Item Name: Crosstube Turning Detail

DART AEROSPACE LTD	Work Order:	95466
Description: Crosstube Assembly (412 Low Aft)	Part Number:	D412-664-249
Inspection Dwg: D412-664-249 Rev: B		Page 1 of 2

DRAWING NO. D412-664-249	TITLE CROSSTUBE ASS'Y (412 LOW AFT)	REV. B	DART AEROSPACE LTD ENGINEERING ORDER		D.E.O. NO. D412-664-249-B-1	SHEET NO. SHEET 1 OF 2	SCALE NTS
DRAWN <i>97</i>	CHECKED <i>SC</i>	MFG. APPR. <i>R</i>	APPROVED <i>MD</i>		DE APPR. <i>MD</i>		
DATE 11.05.25	DATE 11.05.31	DATE 11.05.31	DATE 11/05/31		DATE 11.05.31

DRAWING NO. D412-664-249	TITLE CROSSTUBE (412 LOW AFT)	REV. B	DART AEROSPACE LTD ENGINEERING ORDER		D.E.O. NO. D412-664-249-B-3	SHEET NO. SHEET 1 OF 3	SCALE NTS
DRAWN 97	CHECKED [Signature]	MFG. APPR. [Signature]	APPROVED [Signature]		DE APPR. [Signature]		
DATE 12.08.21	DATE 12.08.30	DATE 12.08.30	DATE 12.08.30		DATE 12.08.30

D412-664-249
ASSEMBLY DETAIL

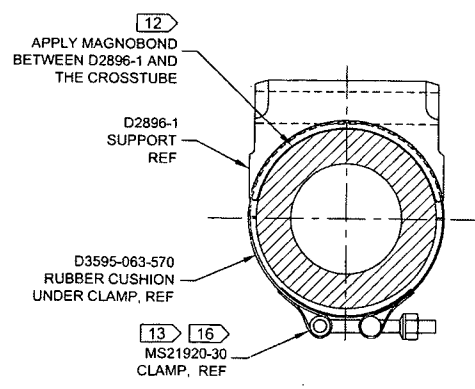
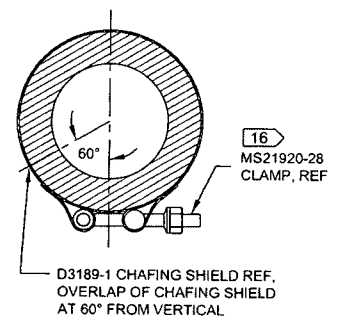
IS:

D3189-1 CHAFING SHIELD (1, INSTALLED OVER PROSEAL 890)
MS21920-28 CLAMP, 2X
2 PL

WAS:

D2856-600-1009 ABRASION STRIP
D3189-1 CHAFING SHIELD (1, INSTALLED OVER ABRASION STRIP)
MS21920-28 CLAMP, 2X
2 PL

**D412-664-249
ASSEMBLY DETAIL**

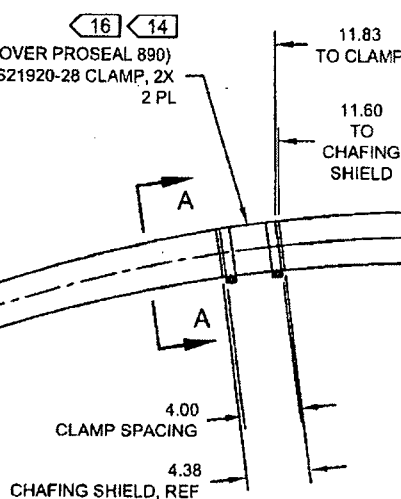
REMOVED ABRASION STRIP IN FAVOR OF A THIN LAYER OF PROSEAL 890. UPDATE INSTALLATION OF CHAFING SHIELDS AND REDUCE TORQUE TO 40-50 IN-LBS. THIS ENGINEERING ORDER SUPERCEDES DEO D412-664-249-B-1

IS:

D3189-1 CHAFING SHIELD (1, INSTALLED OVER PROSEAL 890)
MS21920-28 CLAMP, 2X
2 PL

WAS:

D2856-600-1009 ABRASION STRIP
D3189-1 CHAFING SHIELD (1, INSTALLED OVER ABRASION STRIP)
MS21920-28 CLAMP, 2X
2 PL
